Request	-	Planned Unit Development for multiple commercial buildings
Location	-	3450 W. Central Avenue
Applicant/Owner	-	Westgate Village North, LLC 30 North LaSalle Street, Suite 2120 Chicago, IL 60602
Civil Engineer	-	Woolpert, Inc. 4454 Idea Center Boulevard Dayton, OH 45430
Architect	-	Ethos Workshop Architects 105 W. Jackson Avenue, Ste 2 Naperville, IL 60540

The staff recommends that the Toledo City Plan Commission recommend **approval** of PUD25-0003, a request for a Planned Unit Development for multiple commercial buildings at 3450 W. Central Avenue, to the Toledo City Council, for the following **two (2) reasons**:

PLANNED UNIT DEVELOPMENT
TOLEDO CITY PLAN COMMISSION
REF: PUD25-0003
DATE: September 11, 2025
TIME: 2:00 P.M.

OVERALL SITE PLAN

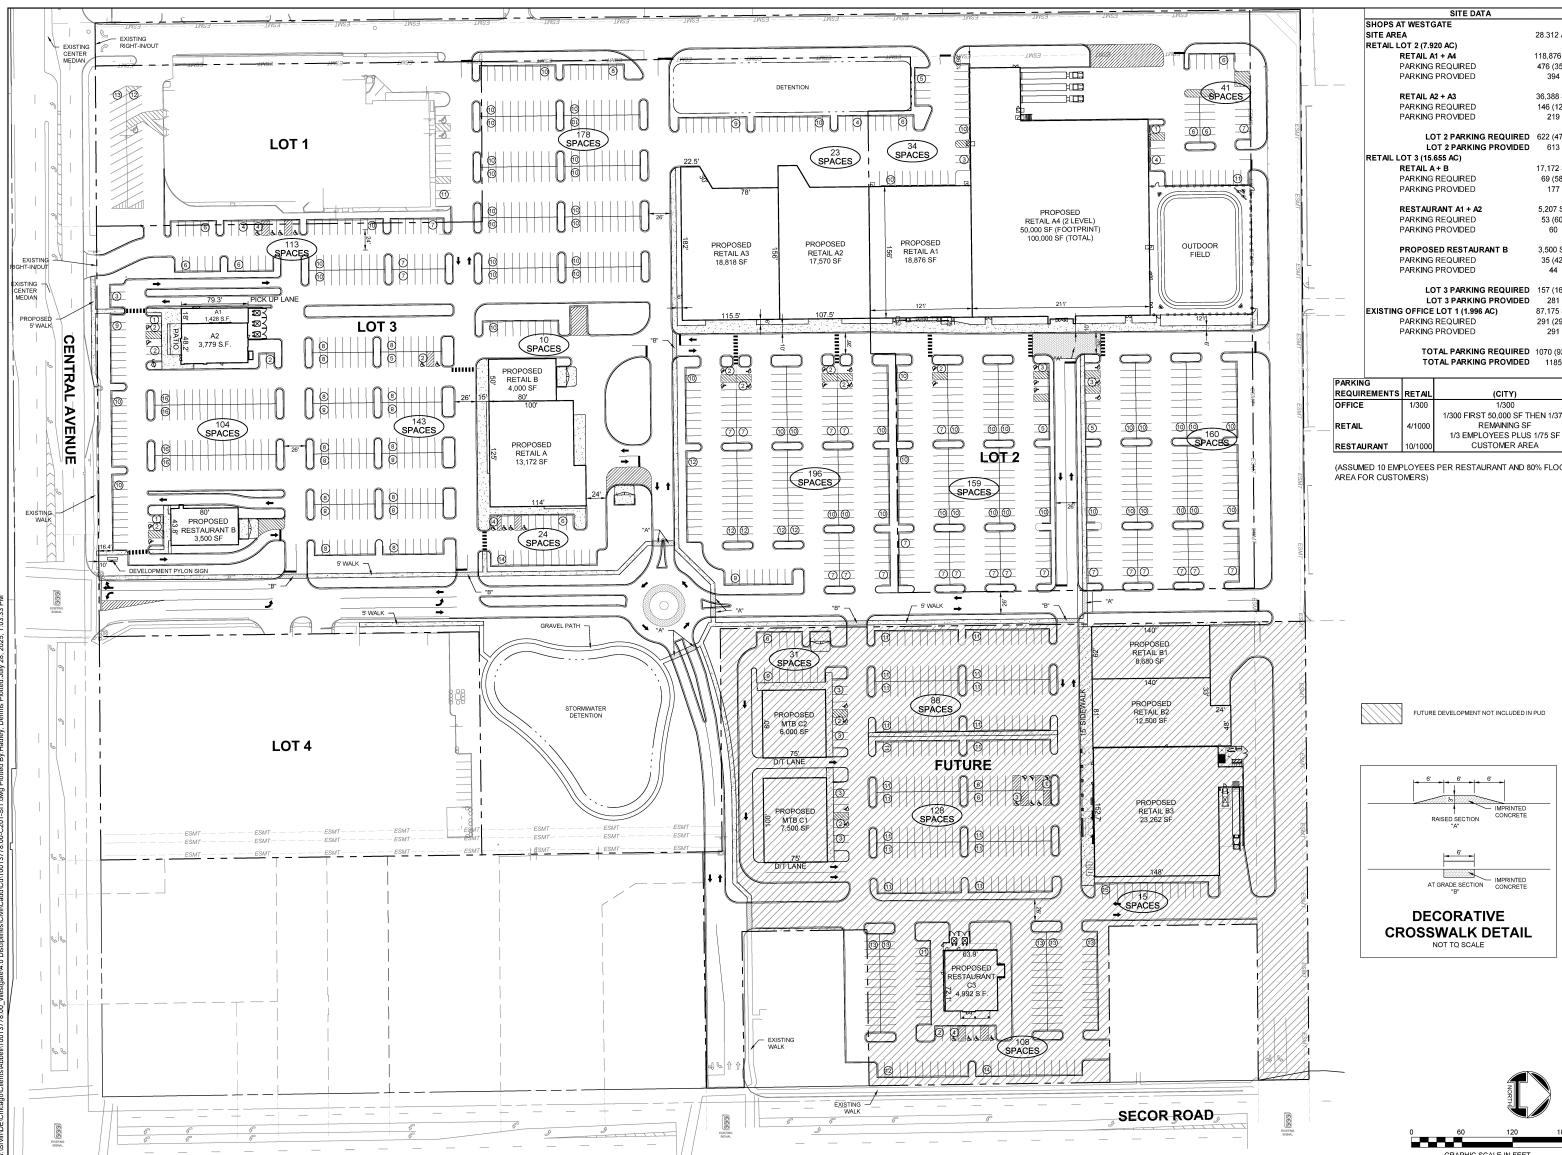
35. Per TMC§1103.1008(D), no more than seventy percent (70%) of the gross site acreage may be covered by buildings, structures, street, driveway, or parking area pavement. **Not acceptable as depicted. A revised site and landscaping plan shall be submitted to the Plan Director showing compliance with TMC§1103.1008(D).**

37. Usable, accessible, and consolidated common open space areas in the amount of no less than ten percent (10%) of the gross site acreage is required per TMC§1103.1008(C). **Not acceptable as depicted. The applicant shall submit a revised site and landscaping plan showing compliance with TMC§1106.1008(C).**

43. Per TMC Sections 1103.1010 & 1109.0304, a direct pedestrian walkway connection shall be added between Central Avenue, the "Outparcel 1 Building" entrance(s), and the "Anchor Retail building entrance(s). **Not acceptable as depicted. The applicant shall submit a revised site and landscaping plan to the Plan Director depicting this required pedestrian walkway connection.**

44. Per TMC Sections 1103.1010 & 1109.0304, direct pedestrian walkway connections shall be added between the existing office building, the "Outparcel 1 Building", the "Multi-tenant Building", and the "Restaurant B / Outparcel 2 Building". **Not acceptable as depicted. The applicant shall submit a revised site and landscaping plan to the Plan Director depicting these required pedestrian walkway connections.**

45. Per TMC§1103.1010, sidewalks are required along all sides of the roundabout, on both sides of the north-south drive aligned with the Central Avenue traffic light intersection, and along both sides of the northern drive aligned with the Secor Road traffic light intersection. **Not acceptable as depicted on site plan. The applicant shall submit a revised site and landscaping plan to the Plan Director depicting sidewalks required by TMC§1103.1010.**

47. All connecting walkways within large-scale retail projects must be a minimum of six feet (6') in width per TMC§1109.0304(A). **Not acceptable as depicted. The applicant shall submit a revised site and landscaping plan to the Plan Director depicting all pedestrian walkways with a minimum width of six feet (6').**

OVERALL LANDSCAPE PLAN

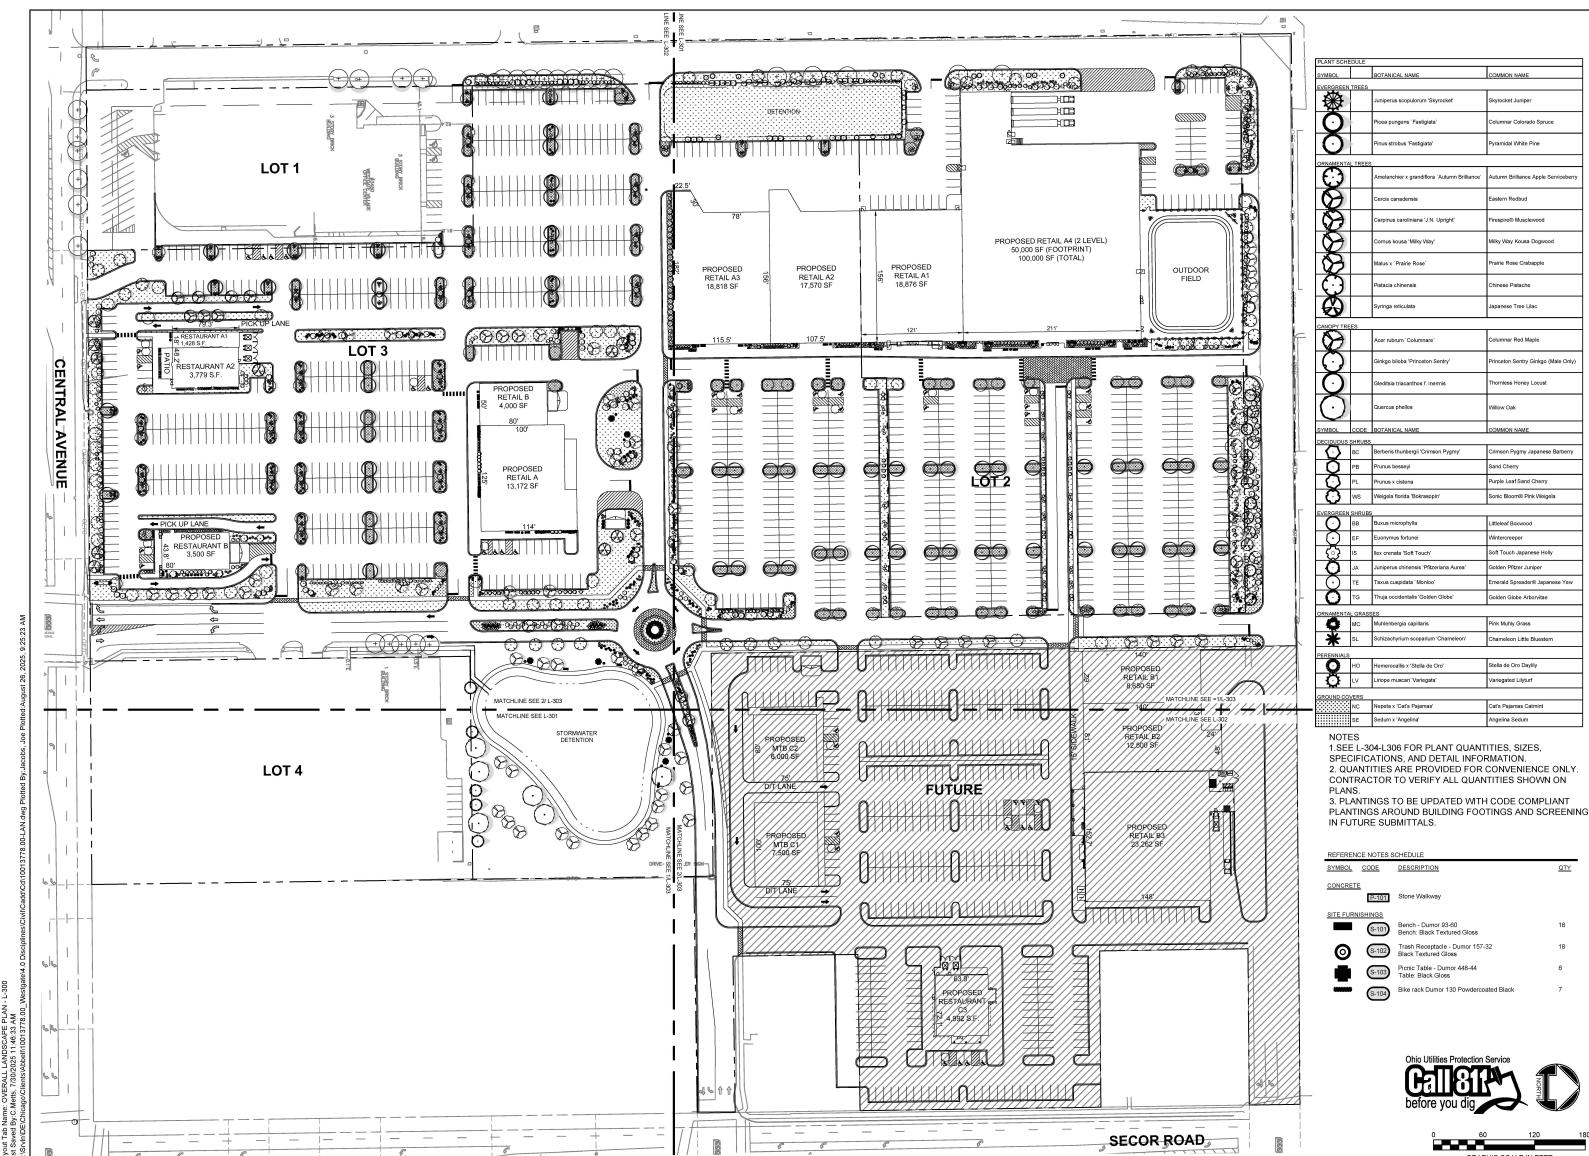
50. Per TMC§1108.0202, a minimum thirty-foot (30') wide frontage greenbelt along Central Avenue is required. This greenbelt must contain at least one (1) tree for every thirty-feet (30') of frontage. **Not acceptable as depicted. A revised landscaping plan shall be submitted to the Plan Director depicting a minimum of twenty-four (24) trees within the Central Avenue frontage greenbelt.**

51. Per TMC§1108.0203, a Type B landscape buffer is required along the western property line. Four (4) canopy trees and fifteen (15) shrubs are required within the buffer per 100 linear feet. Type B landscape buffer materials may be placed within the required open space area adjacent to the western drive aisle in lieu of the PUD perimeter open space area. **Not acceptable as depicted. The applicant shall submit a revised landscape plan to the Plan Director depicting a minimum of sixty (60) canopy trees and 225 shrubs.**

54. In addition to other landscape requirements for buffer areas, frontage greenbelts, and parking lot perimeters, 368 trees and 711 shrubs are required between the parking lot interior requirements of TMC§1108.0204 and the site interior requirements of TMC§1108.0205(B). **Not acceptable as depicted. The applicant shall submit a revised landscaping plan depicting a minimum of 368 trees and 711 shrubs within the interior of this site (not including materials required for buffer areas, frontage greenbelts, or parking lot perimeters). A sufficient number of these trees shall be depicted within the parking lot interior so as impervious surfaces are sufficiently covered with canopy trees as determined by the Plan Director.**

"ANCHOR BUILDING" - NORTHERN SECTION

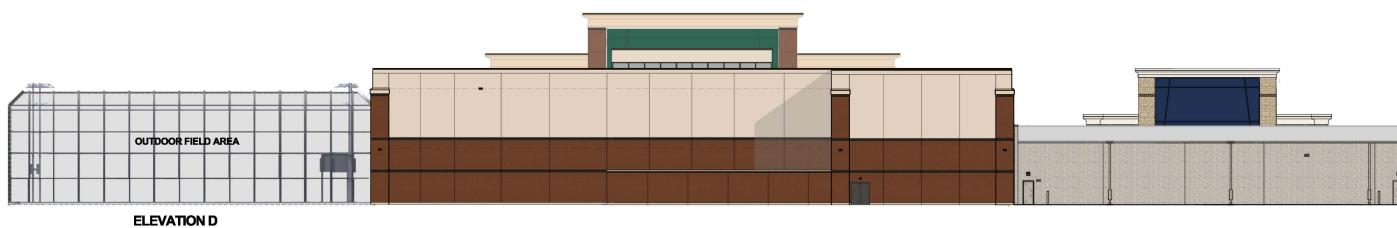
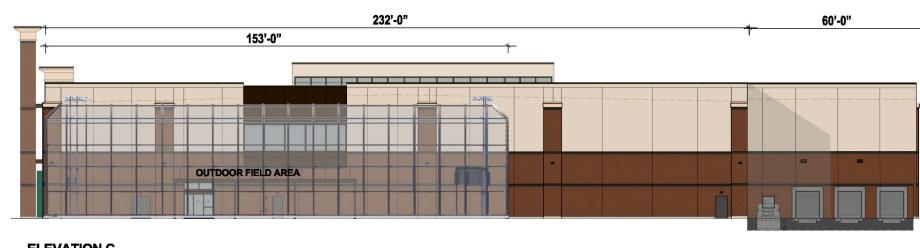
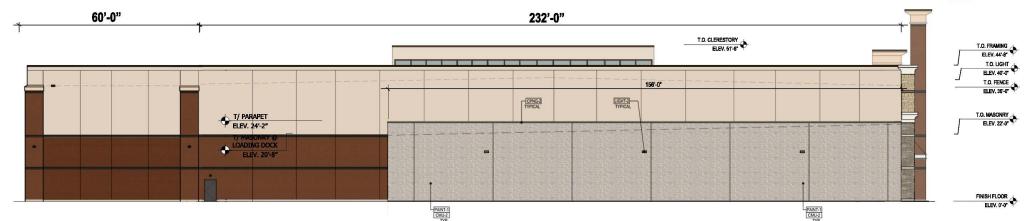
The northern portion of the anchor building has one (1) elevation visible from the right-of-way: the eastern elevation. The materials of this elevation are not spelled out, but it appears the elevation is comprised of roughly sixty-five percent (65%) predominant materials (masonry, windows, and architectural metal) and thirty-five percent (35%) accent materials (EIFS or stucco). As a condition of approval, the applicant shall submit revised elevation drawings with materials specified and showing compliance with TMC§1109.0500.

- b. **The northern portion of the “Anchor Building” is not acceptable as depicted. The applicant shall submit revised elevation drawings to the Plan Director with a percentage material break down showing compliance with TMC§1109.0500.**
